RESPONSE TO REQUEST FOR ADDITIONAL INFORMATION

APR1400 Design Certification

Docket No. 52-046

RAI No.: 457-8558
SRP Section: 09.01.05 - Overhead Heavy Load Handling Systems
Application Section: DCD Subsection 9.1.5
Date of RAI Issue: 04/06/2016

Figure 1. Load Handling Equipments in Fuel Handling Area

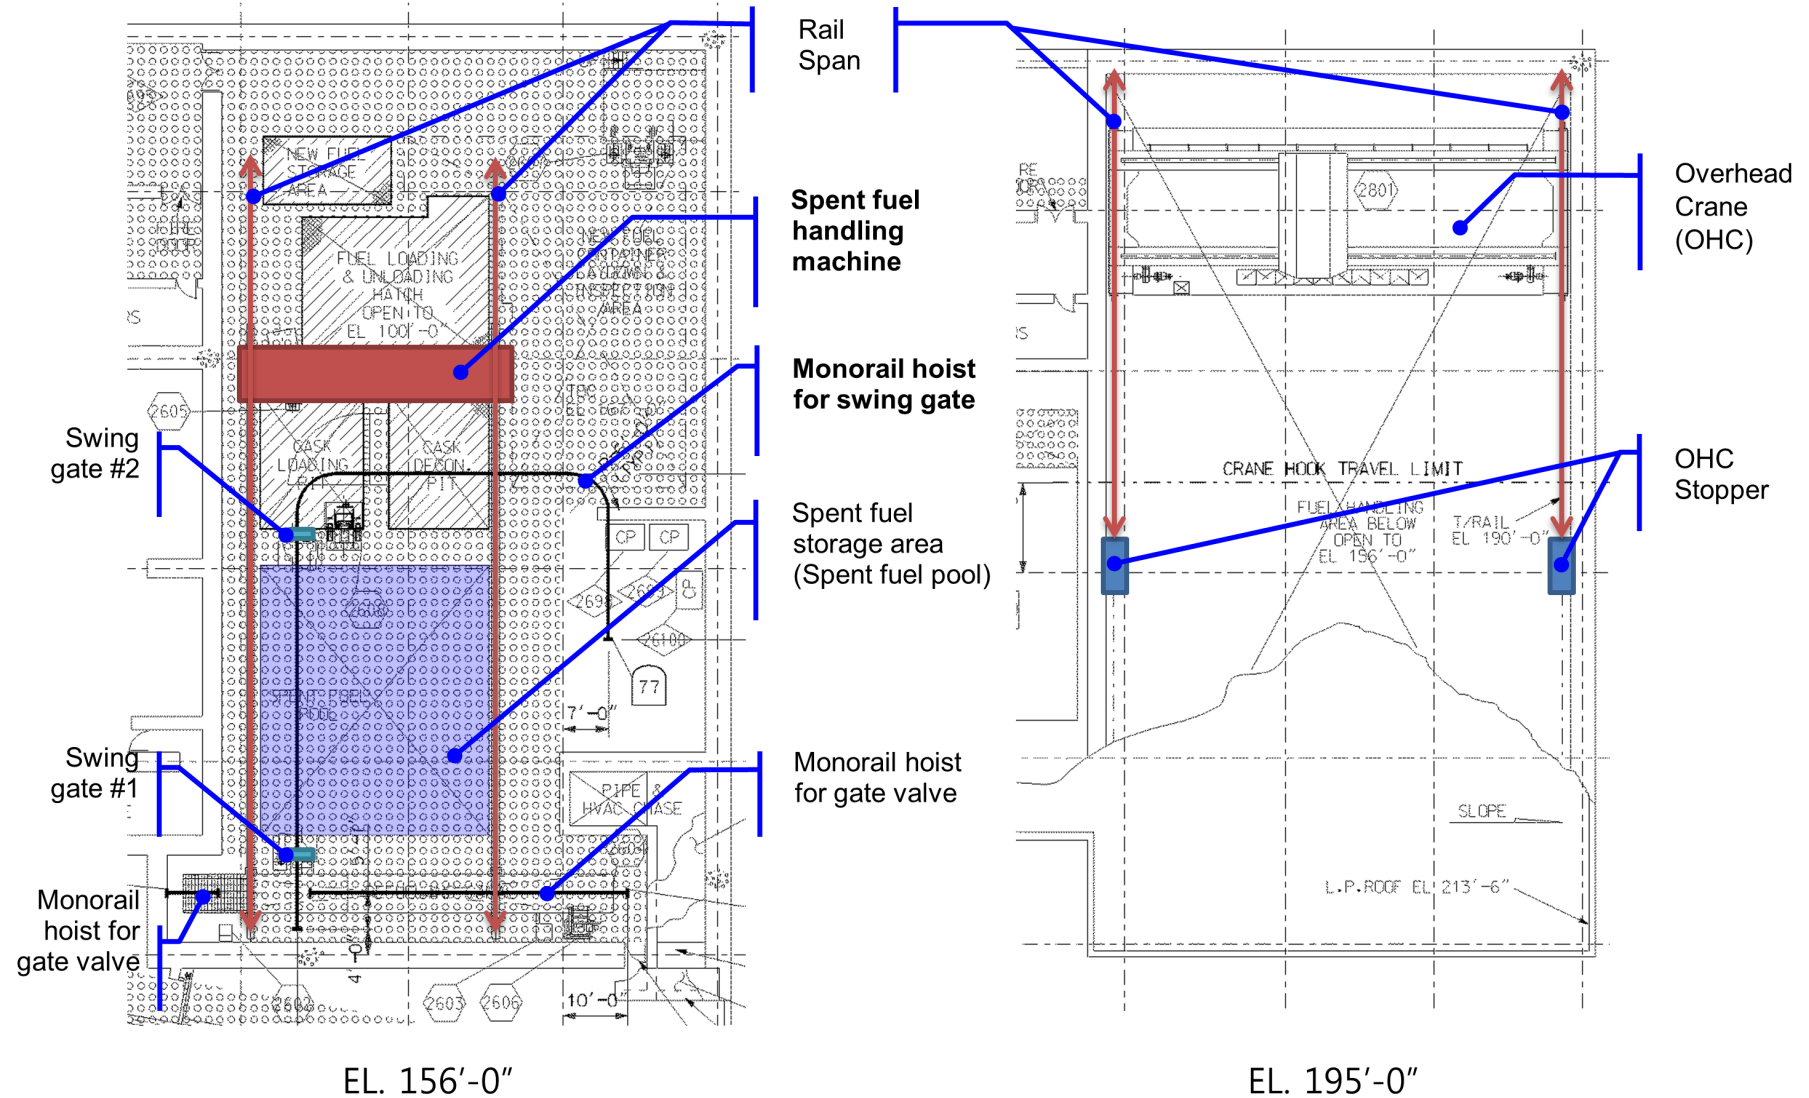
The applicant is requested to identify the crane that is used to handle the spent fuel assembly with its handling tool and a swing gate as discussed in the above response, and revise DCD, Tier 2 Section 9.1.5.3, to reflect that the fuel handling area overhead crane is not “single-failure-proof.”

The spent fuel handling machine handles the spent fuel assembly with its handling tool. The monorail hoist for the swing gate handles the swing gate. Both cranes are shown in Attachment 2.
